Re: Florida Power & Light Company
Proposed Turkey Point Units 6 and 7
Docket Nos. 52-040 and 52-041
Response to NRC Request for Additional Information Letter No. 017 (eRAI 5192)
Standard Review Plan Section 09.05.02 – Communication Systems

Proposed Turkey Point Units 6 and 7
Docket Nos. 52-040 and 52-041
FPL Response to NRC RAI No. 09.05.02-1 (eRAI 5192)
L-2011-086 Attachment 1 Page 1 of 4

NRC RAI Number: 09.05.02-1 (e-RAI 5192)

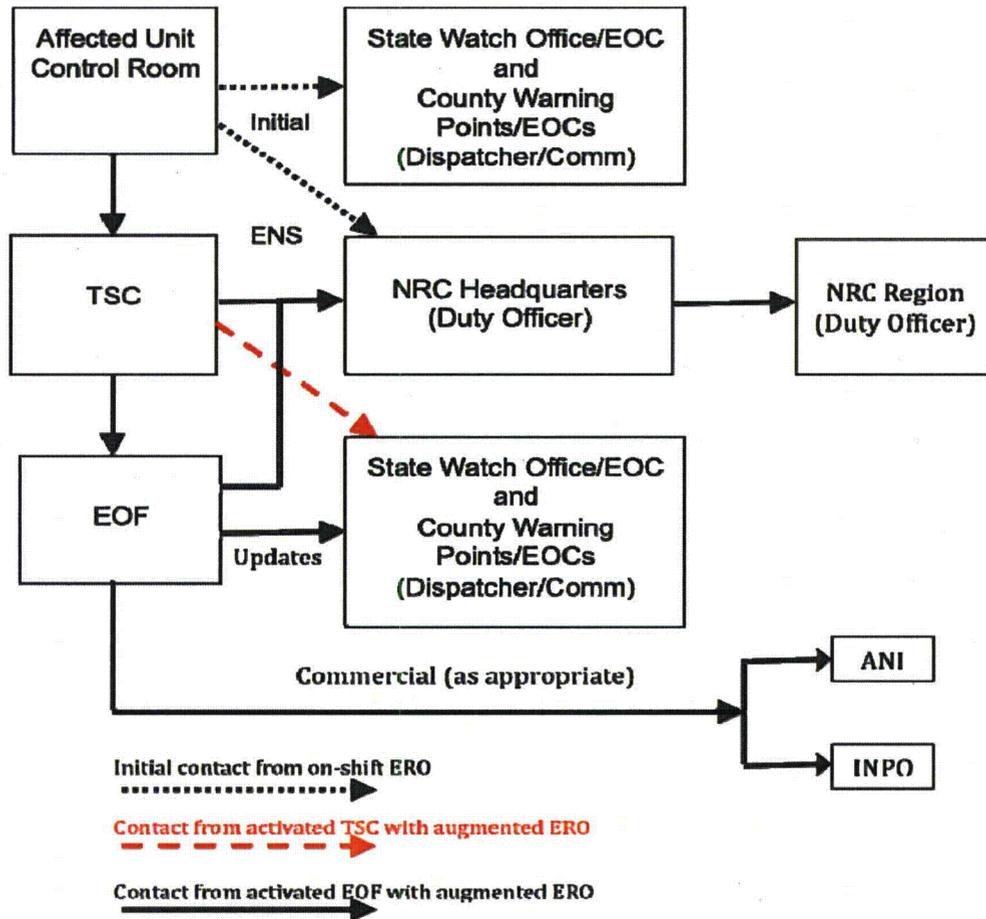
Please identify the primary and secondary means of communications between the plant (CR and TSC) and state/local governments, federal emergency response organizations, the EOF, the NRC, the EOCs, and the field assessment teams, and add this information to the Final Safety Analysis Report (FSAR) and/or the Emergency Plan.

In addition, Figure F-1 Notification Scheme (after Full Augmentation), will be modified to show the additional communication link to the offsite agencies by the Technical Support Center (TSC) when it is activated at an Alert level emergency and a Site Area Emergency, when it is staffed prior to the Emergency Operations Facility (EOF) activation. When the EOF is activated, all offsite communications are transferred from either the Control Room or the TSC to the EOF.

The revised figure with additions is shown below:
